Project Name: **BRW&S H2GO Administrative and Field Operations Complex (A+FO Complex)**
Adjacent to 146 Gregory Road, NE
Belville, NC 28451

Architect's Project Number: #342302

ADDENDUM NUMBER ONE

02-A1

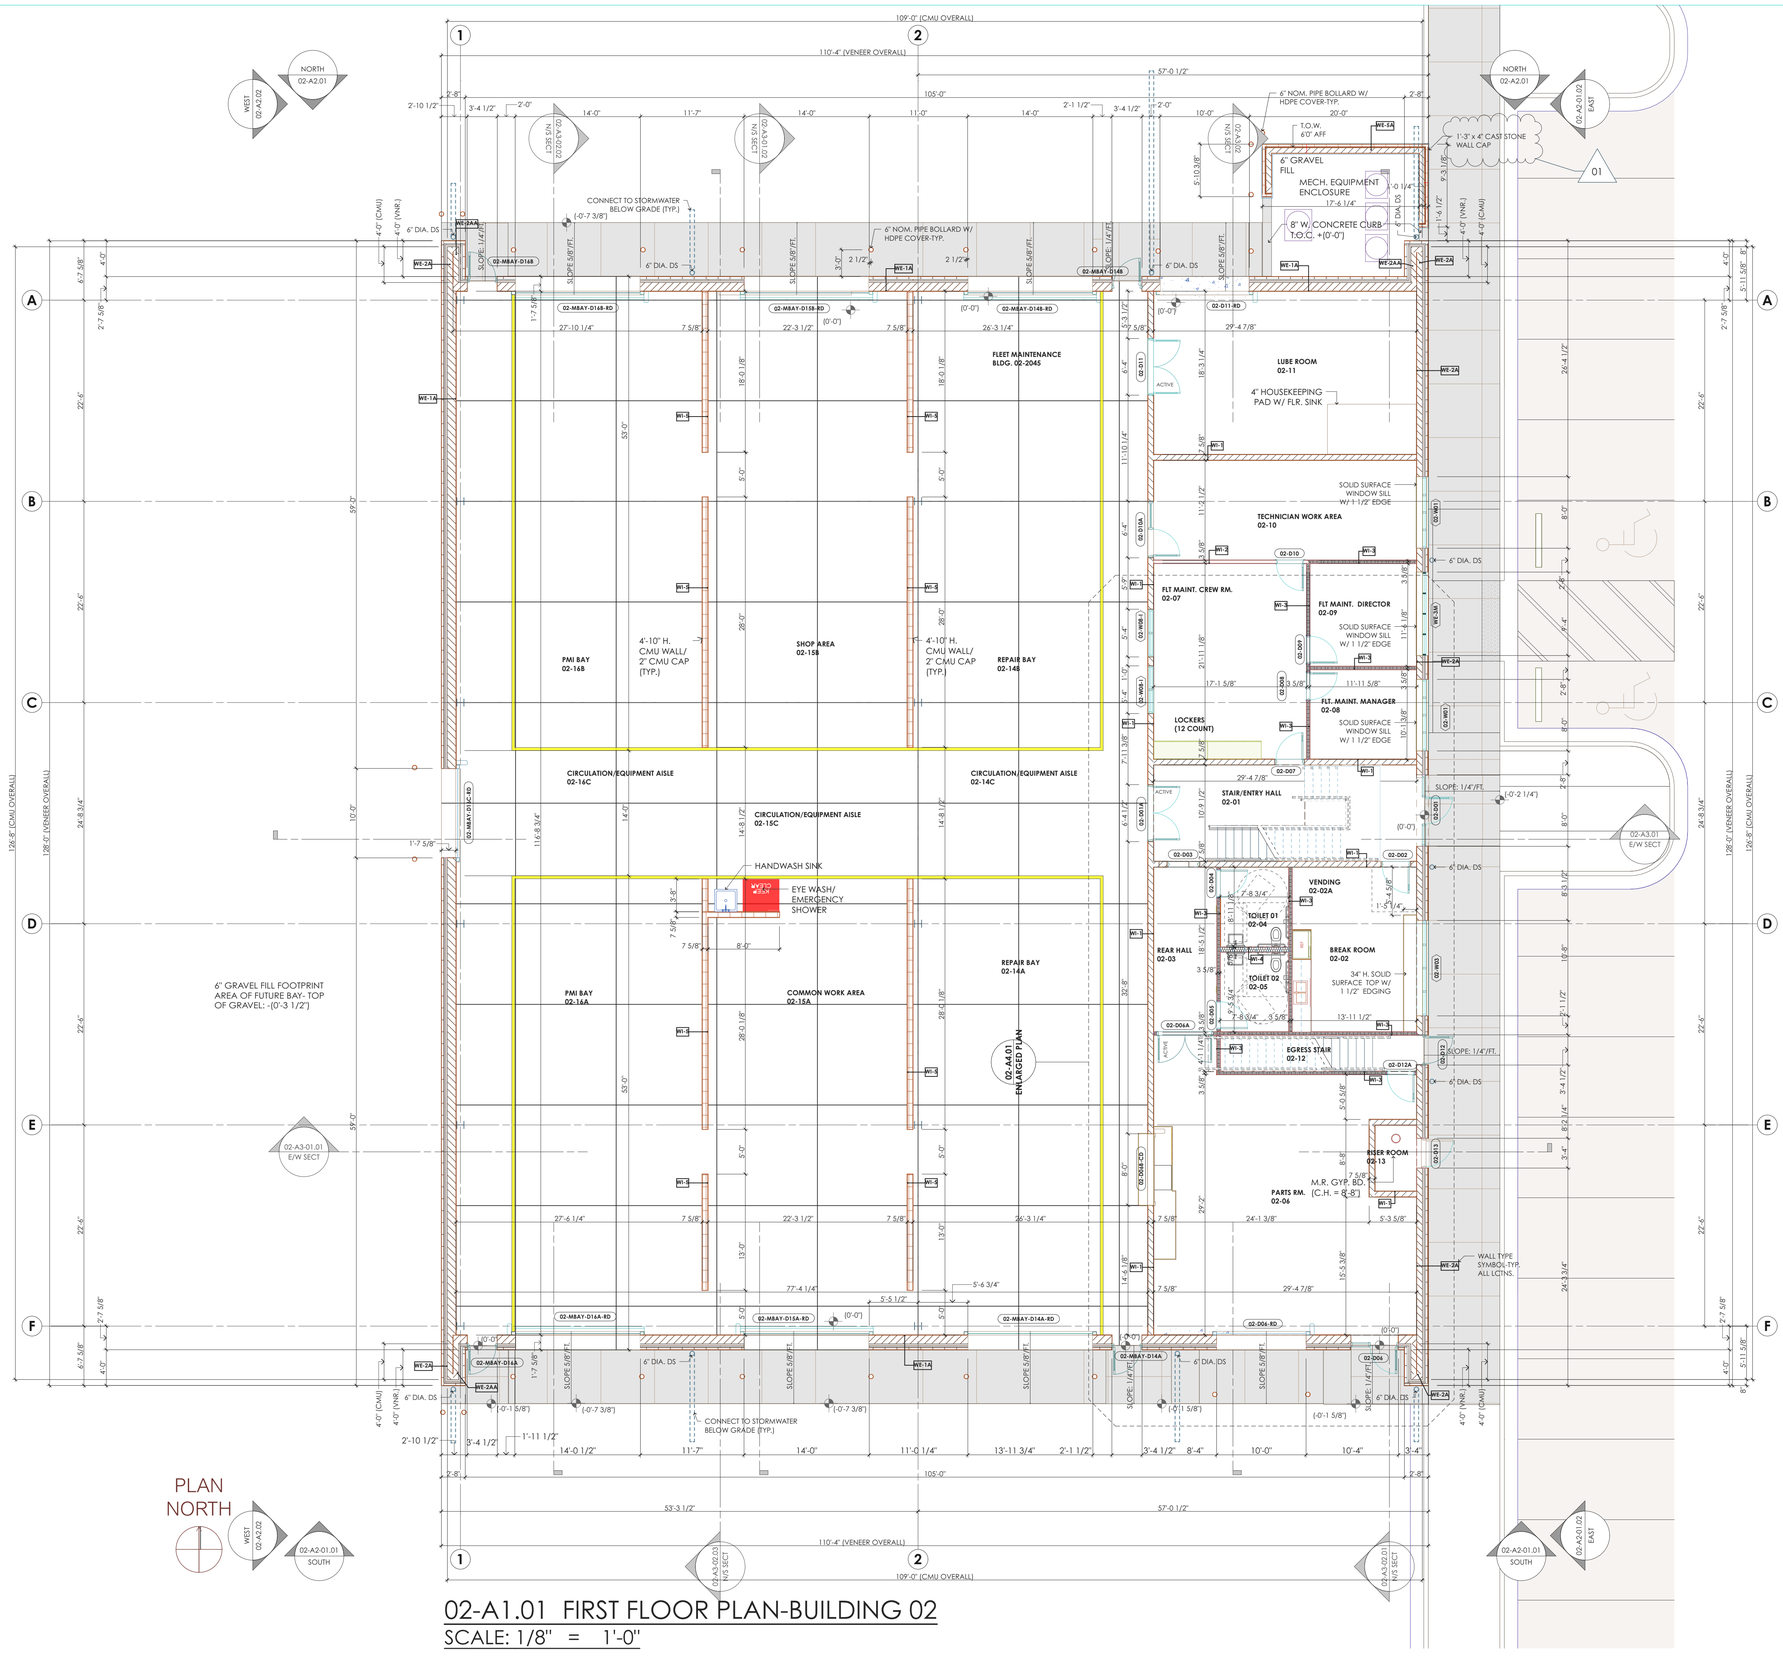
Change 01: Add cast stone wall caps at Mechanical Screen wall with notes.

- **Sheet 02-A1 First Floor Plan:** Added 4" Thick Cast Stone Wall Cap w/ 3/4"/ft. slopes w/ recessed bottom for wall thickness. (ID 01)
- **Sheet 02-A1-04 Roof Plan: NEW SHEET** (ID 02)
- **Sheet 02-A2 Elevations:** Added Cast Stone Wall Cap (ID 01) and Revised Wall Material (ID 05)
- **Sheet 02-A2-01 Elevations:** Added Cast Stone Wall Cap (ID 01), Revised Sills (ID 04) and Revised Wall Material (ID 05)
- **Sheet 02-A5 Wall Types Legend Details: NEW SHEET** (ID 03)

02-A1-04

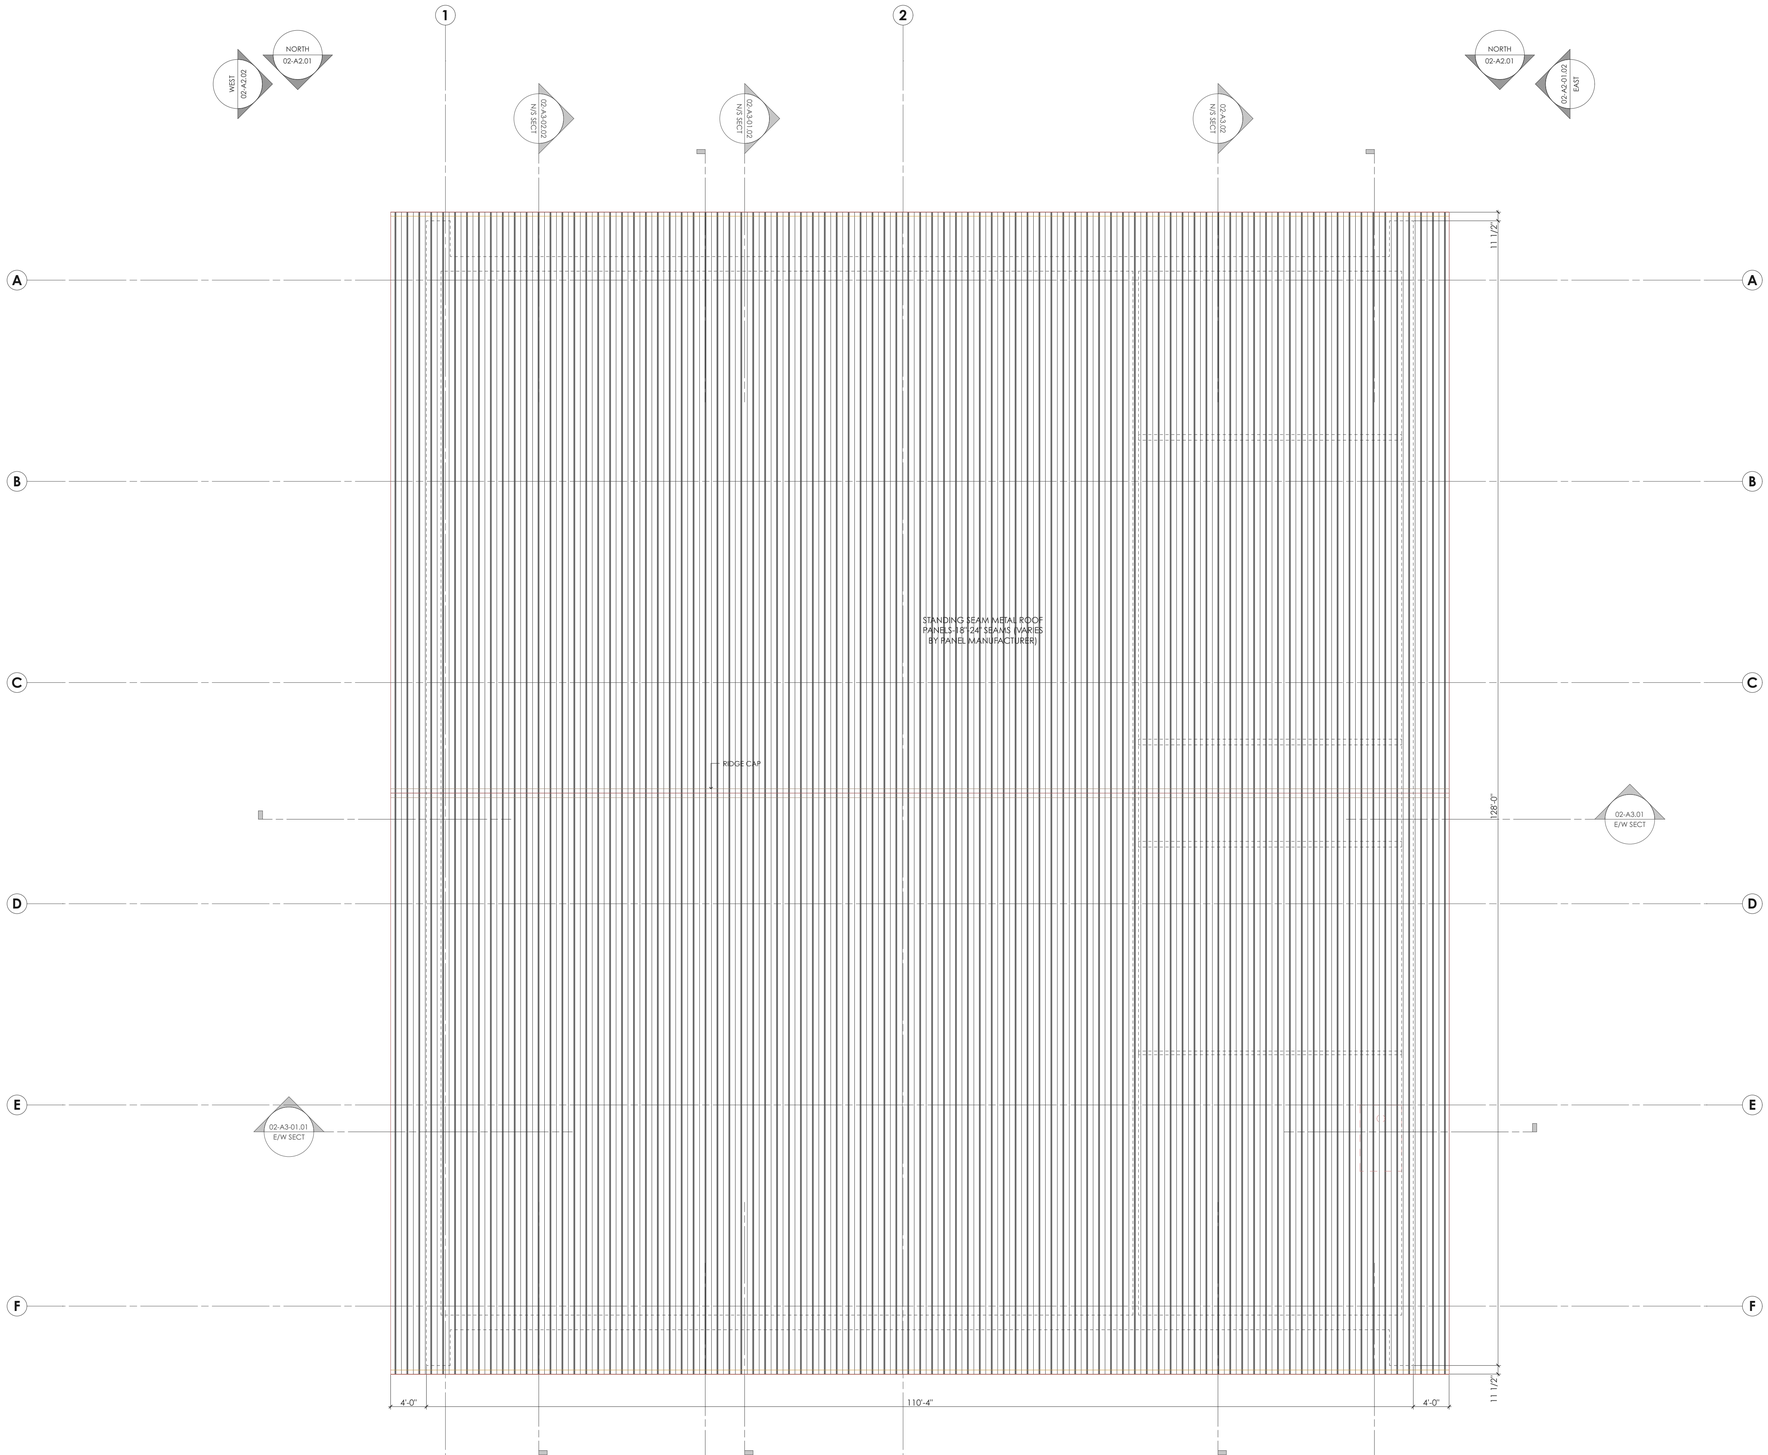
Change 02: Add new sheet 02-A2-01 with drawing 02-A2-01.01 Roof Plan Building 02

02-A2

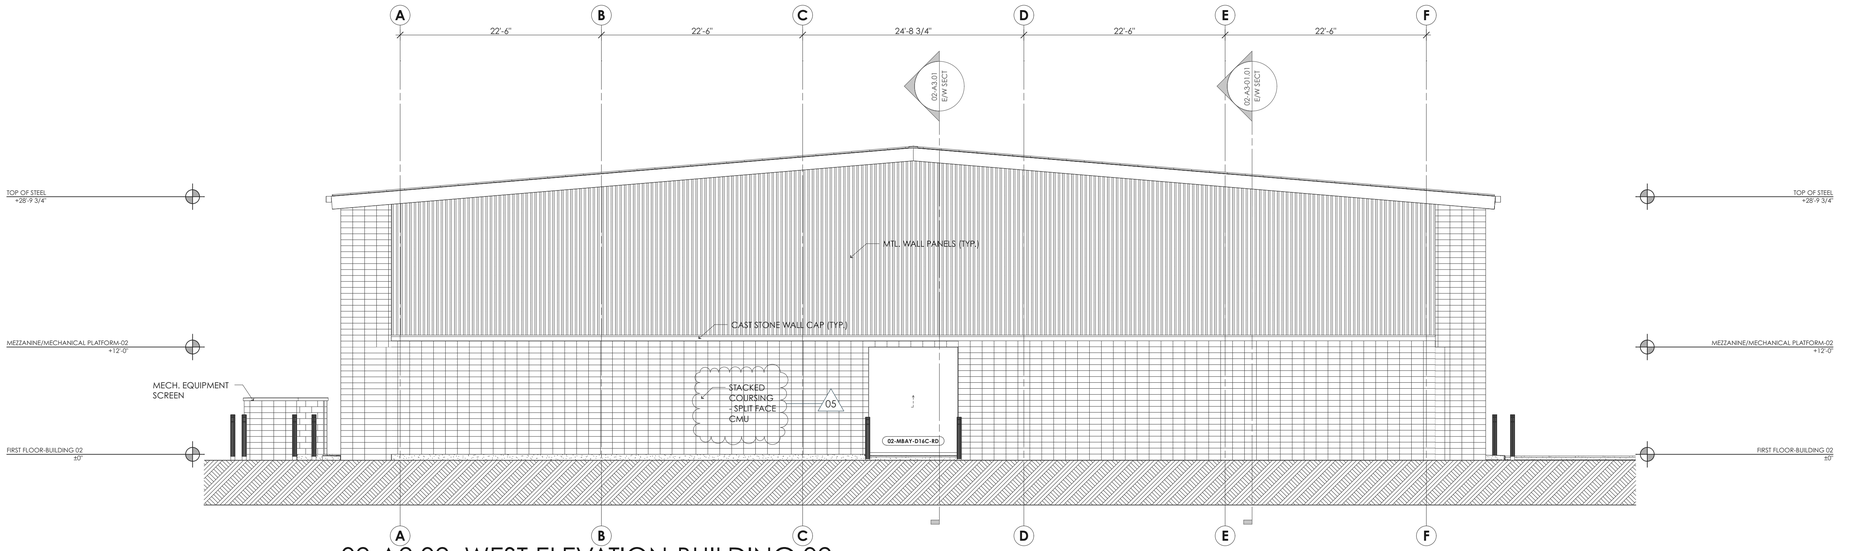
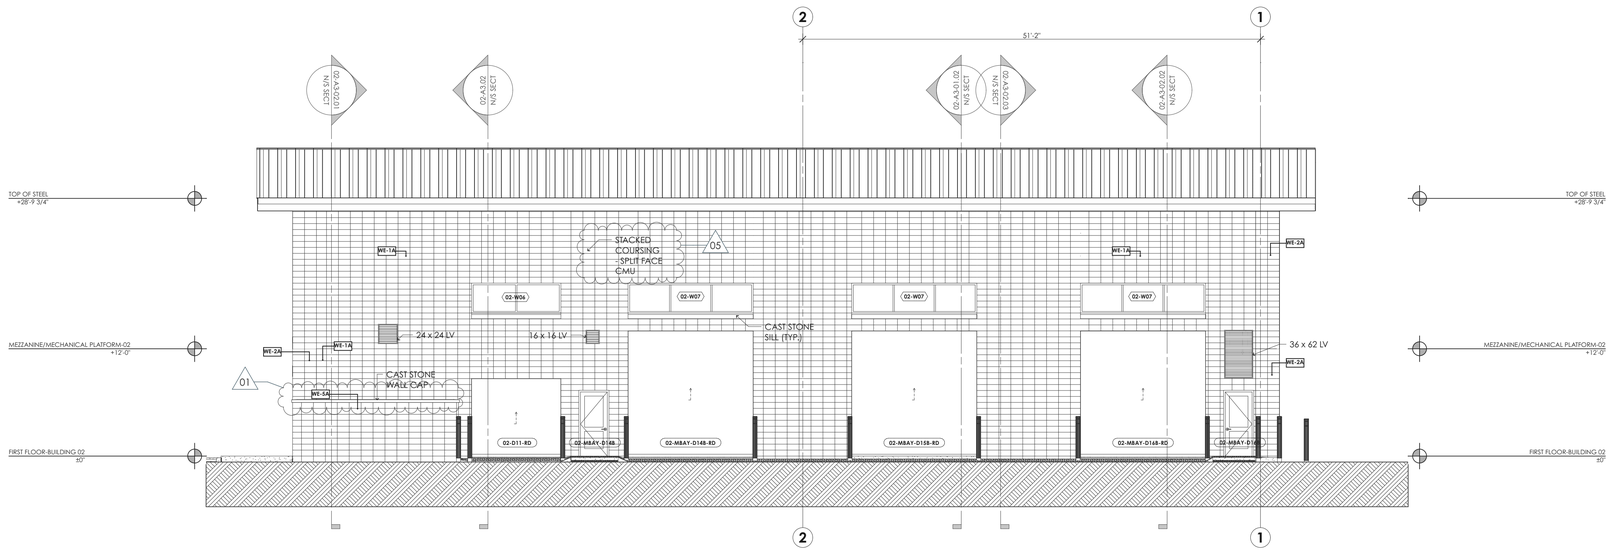
Change 04: Change material for GFM window sills to Cast Stone sills.

Change 05: Change wall material notes for concrete masonry finish from GFM to Split-Face CMU.

03-A1

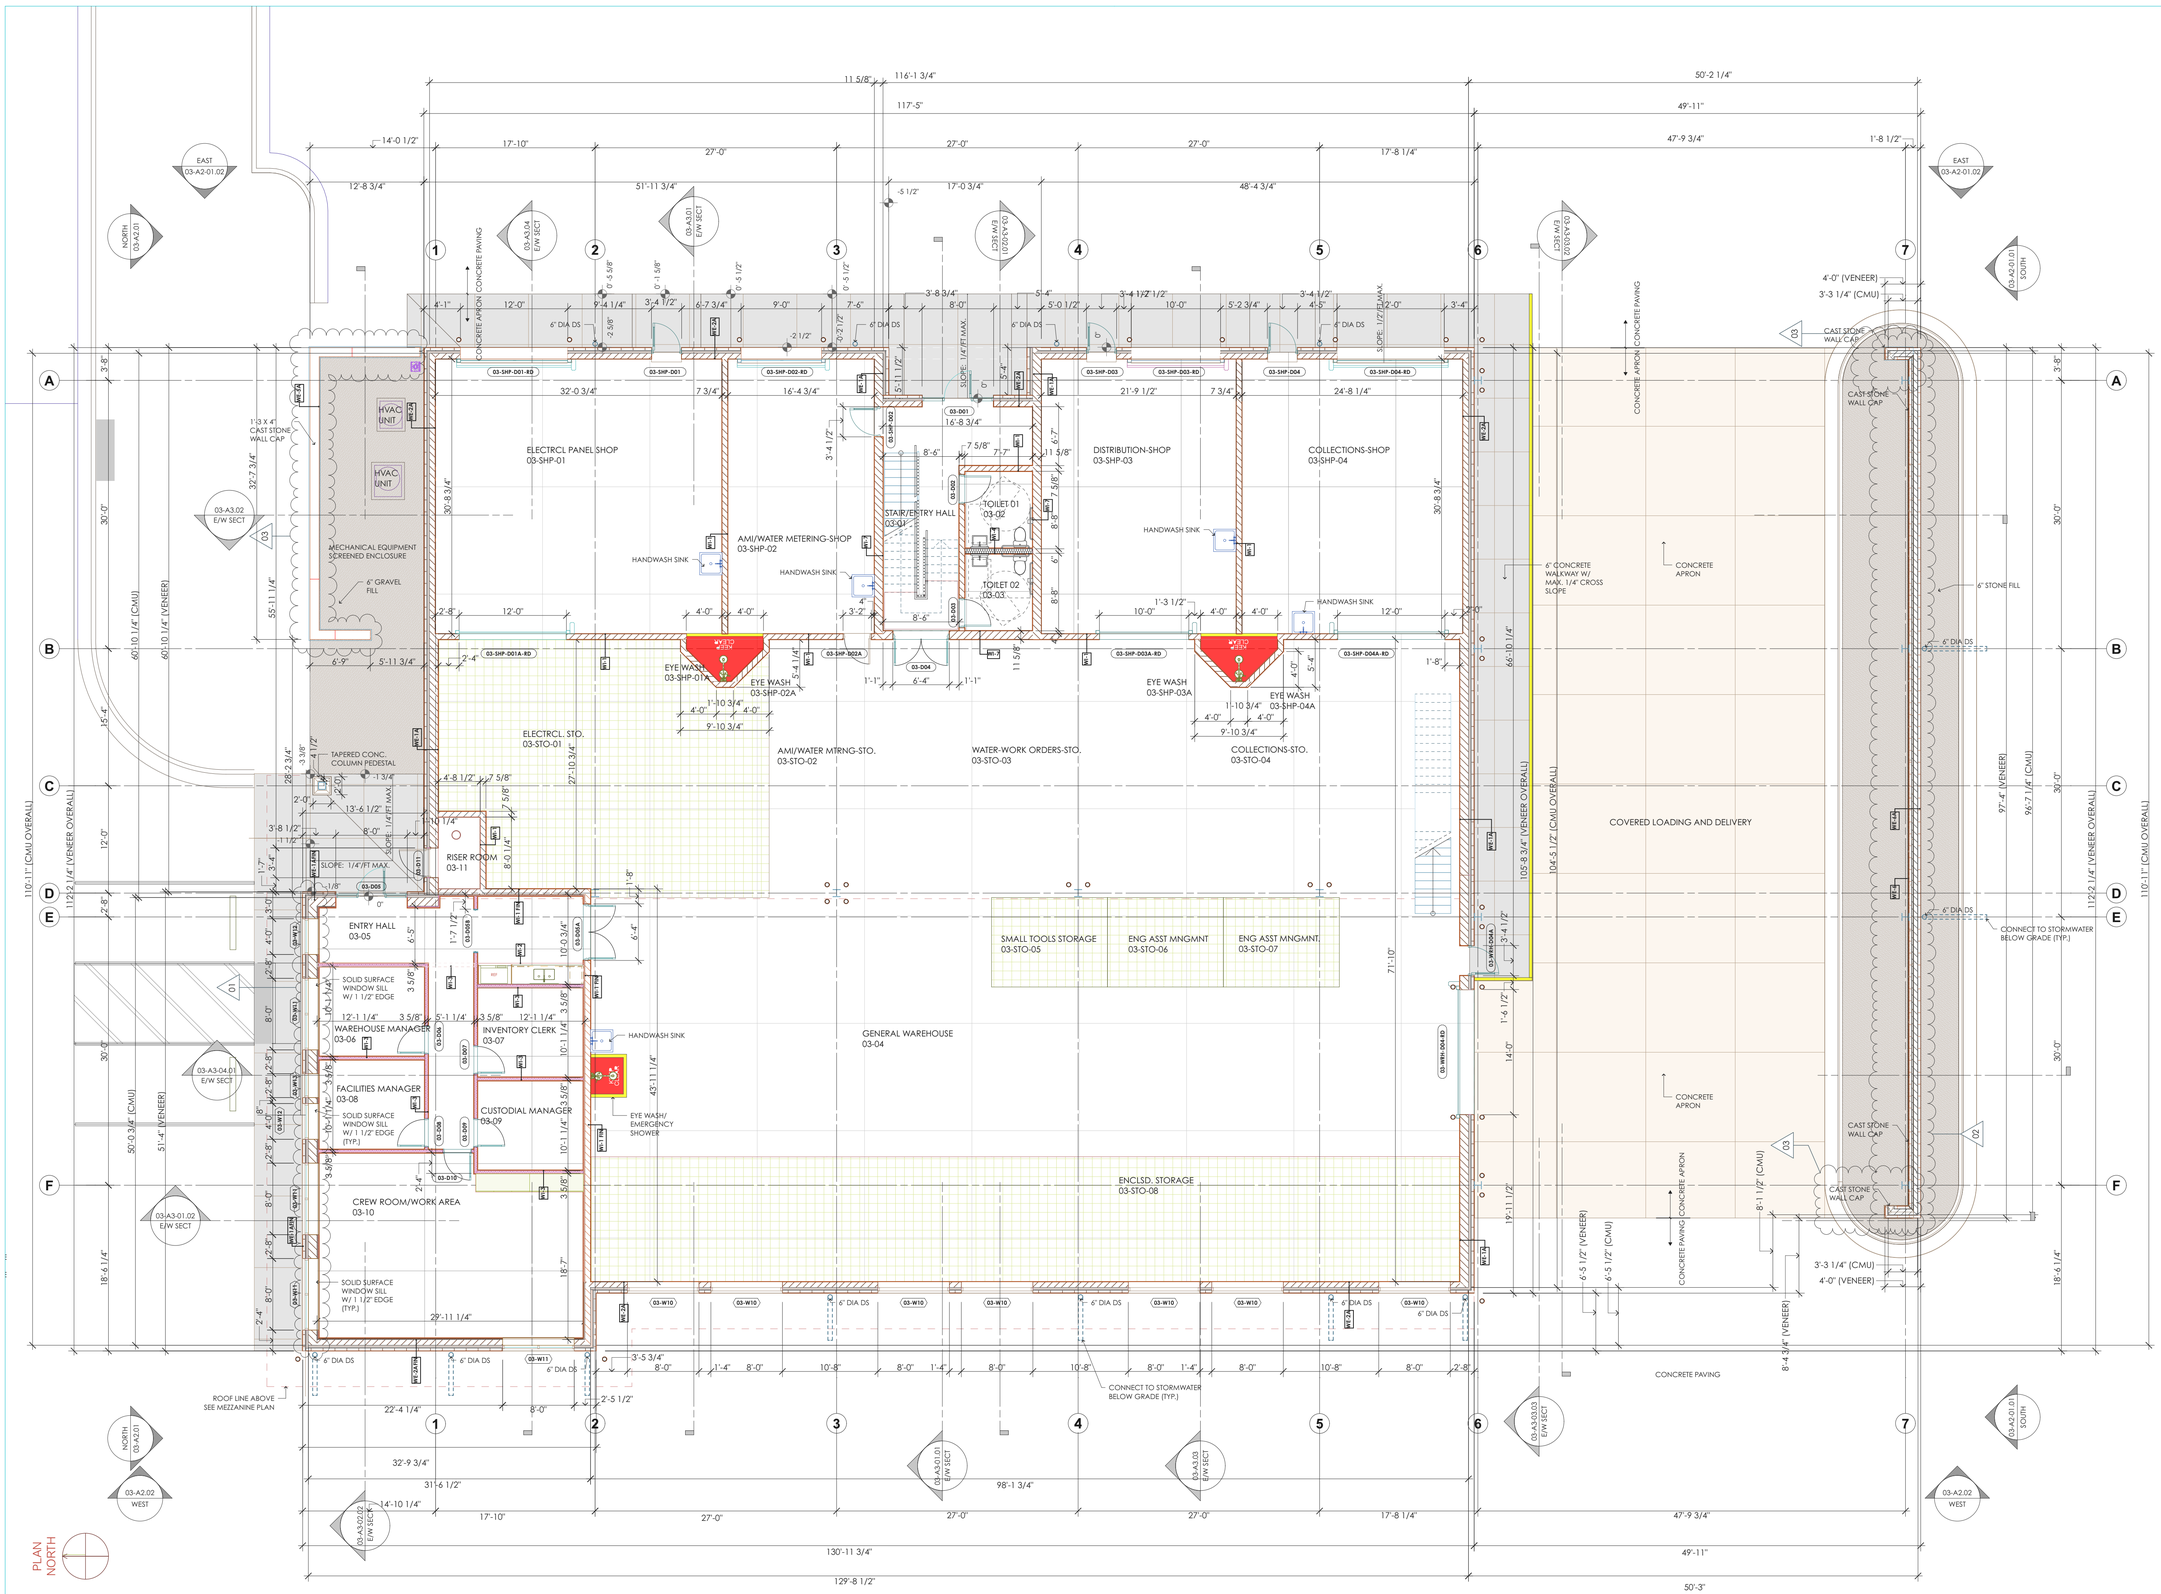
Change 01: Change wall type from 8" CMU to wall type with 12" CMU.

Change North wall of office area from WE-2AFIN to WE-1AFIN.

Change 02: Revise original wall type label and add additional wall type on Column Line 7.

Change wall type labeled WE-6A to WE-6. Add Wall Type WE-6A for the wall type above Wall Type WE-6.

Change 03: Add Cast Stone Wall Cap for Wall Type WE-6 at Column Line 7.

Add 4" thick Cast Stone Wall cap at top of Wall Type WE-6 at wall returns and abutting Wall Type WE-6A along full length of masonry wall (maximum segment length of 4'-0") to returned ends w/edge cutouts at steel columns. Return wall sections are sloped at sides and exposed ends with 1" overhangs and 3/4" per foot slope.

- **Sheet 03-A1 First Floor Plan:** Changed CMU from 8" to 12" (ID 01), Revised/Add Wall Types (ID 02), and Added Cast Stone Wall Cap (ID 03)
- **Sheet 03-A2 N/W/ Building Elevations:** Added Cast Stone Wall Cap (ID 03), Revised Wall Description (ID 04), and Added Cast Stone Sill Note (ID 05)
